RE: North Rose Wolcott CSD 2017 Capital Improvement Project
Leavenworth Middle School – Retaining Wall Revisions

Re: North Rose-Wolcott Central School District
6168 West Port Bay Road, Wolcott, NY 14590
2017 Capital Improvement Project
North Rose-Wolcott Middle School Retaining Wall Change Order (GT-38)
SED# 65-15-01-06-0-001-016
SWBR Project No. 17225.00

CHANGE ORDER NUMBER: GT-038
INITIATION DATE: June 7, 2019

Regarding: RFP GT-144 Retaining Wall B Revisions (RFP)

LEAVENWORTH MIDDLE SCHOOL: RETAINING WALL B CHANGE

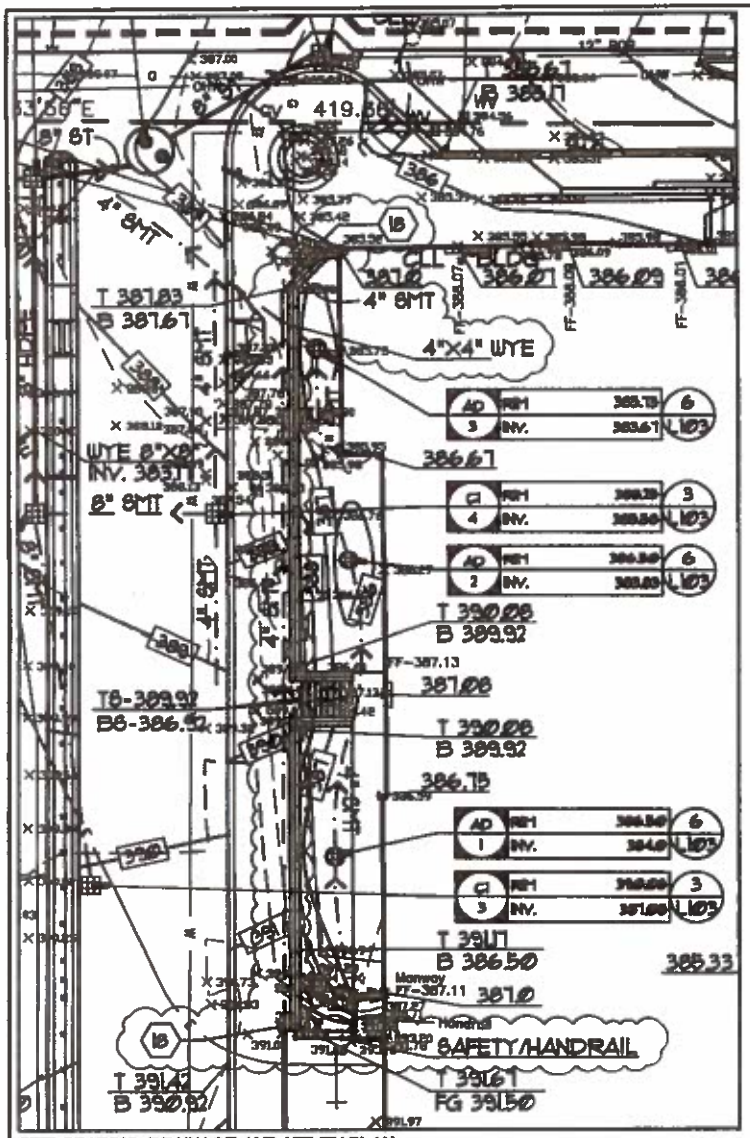
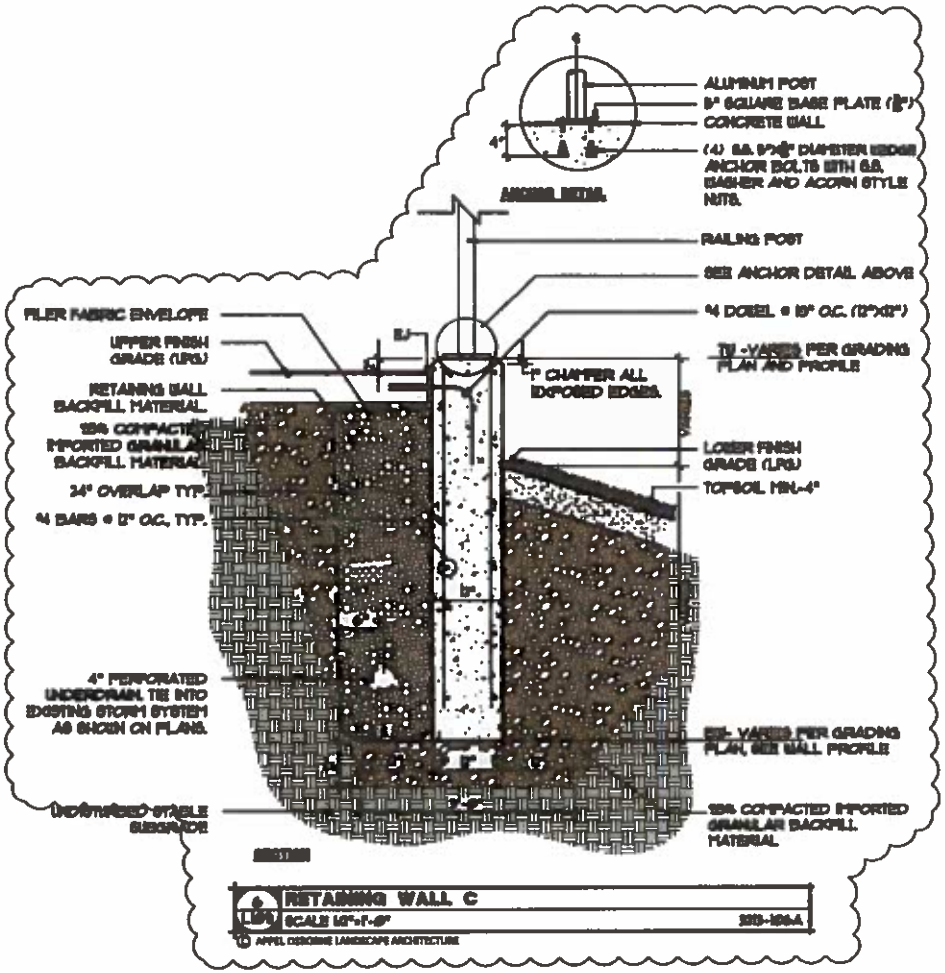
During the North Rose Wolcott CSD, Leavenworth Middle School renovation; it was found that it was necessary to revise the design for the retaining wall that runs the length of West side of the building to add support for the wall structure. These changes included adding a footer at the base of the retaining wall along with dowels through the wall per revised drawing JD-L8R issued by Appel Osborne for RFP GT-144.

Unforeseen location of an existing underground gas line required revisions to a currently designed retaining wall along with an addition of a footing to the wall.

The construction documents call for a retaining wall, the existing survey shows the gas line adjacent to the planned retaining wall. However, during excavation it was found that the gas line was located under the planned retaining wall. In conversation with local utility company, they requested a relocation of the gas line. As part of the revisions to the relocate the gas line, it was determined that the footing is required to be added to the retaining wall. Being that there was already a retaining wall in the project, the products required to do this additional work were already part of the project.

Attached drawing includes revisions to retaining wall B at the middle school.

① RETAINING WALL B ELEVATION

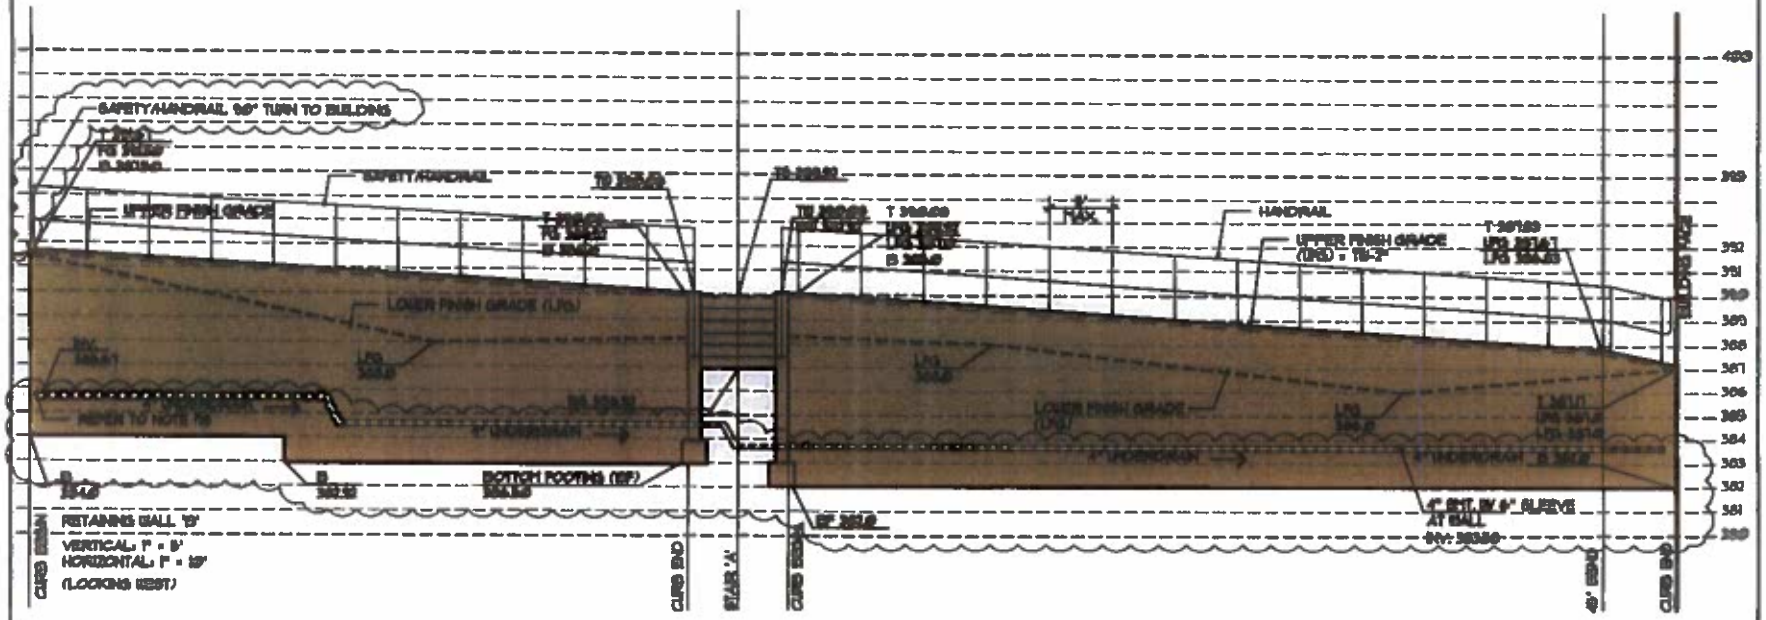
PCO No	Description		Amount
104	The Section at retaining wall B was revised and Elevations were revised. The changes added 3,600 lbs. 900 lbs of the additional weight is PC-11 and the balance is PC-16.	Subtotal	$4,971.00
		Tax@0%	$0.00
		Total	**$4,971.00**
